SUBJECT: DEPARTMENT OF WASTE RESOURCES: Contract Change Order No. 1 and No. 2 for the Construction of the 2016 Site Maintenance and Improvements Project at the Badlands and Pedley Landfills, District 2 & 5 [\$429,967.76 – Department of Waste Resources Enterprise Funds], CEQA Exempt

CONTRACT CHANGE ORDER NO. 1

| NO. 4: Sheet 4 - Refuse Excavation                 |                                 |                            |                            |

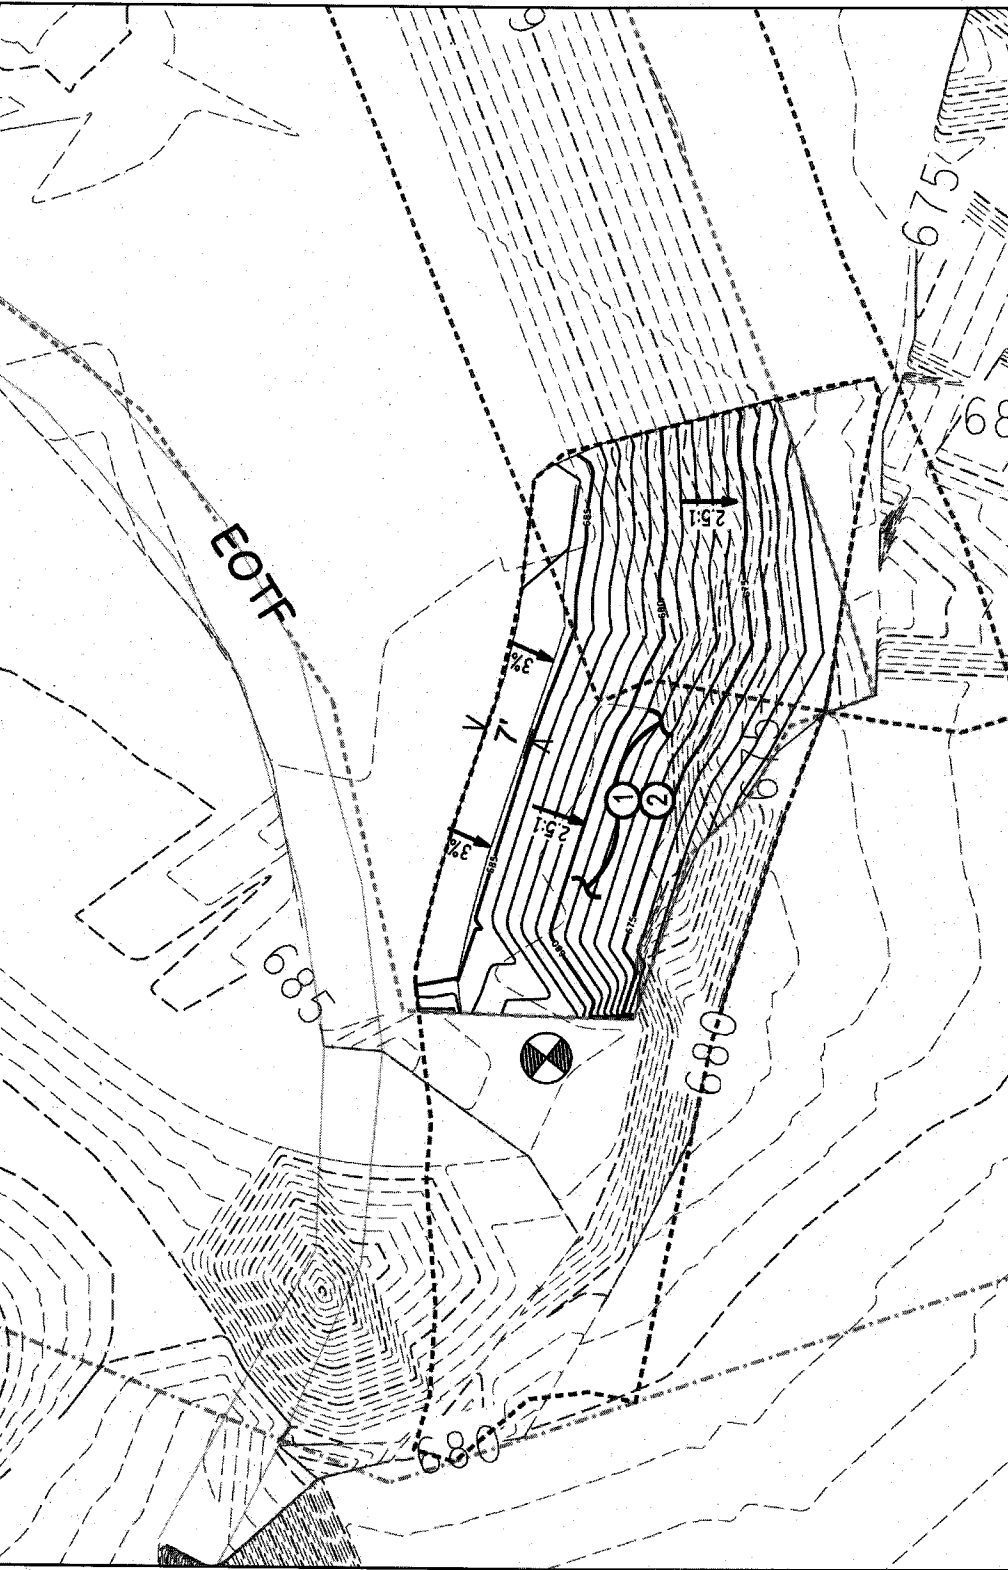
- ① Excavate refuse to the lines and grades shown on this Project Drawing.
- ② Stockpile excavated refuse along Top Deck and cover with a min. 2' of soil as directed by the County.

Approximate Refuse  
Excavation Quantity: 350 CY

| DATE  | Sheet 6 - Engineered Fill                  |

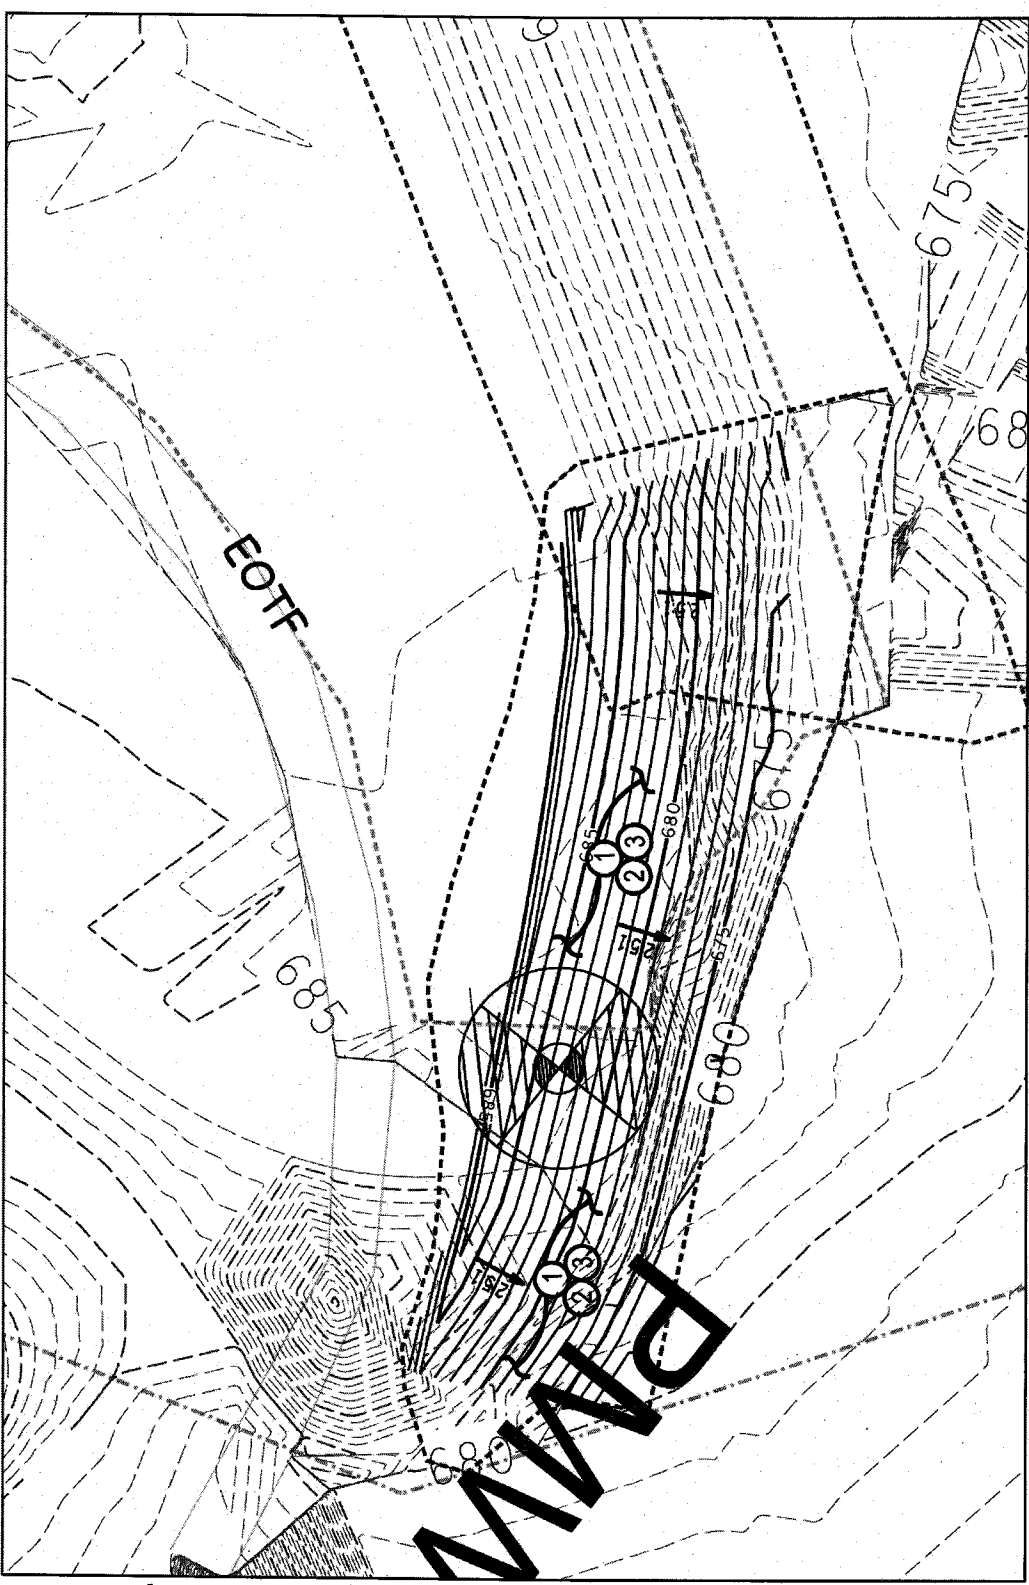
- 1 Place and prepare engineered fill to the lines and grades shown on sheet 6 and 7.
- 2 Construct ACB mat termination trench perpendicular to the slope and install ACB per manufacturer's recommendations.
- 3 Apply soil backfill over ACB and hydrossed in accordance with Contract Specifications.
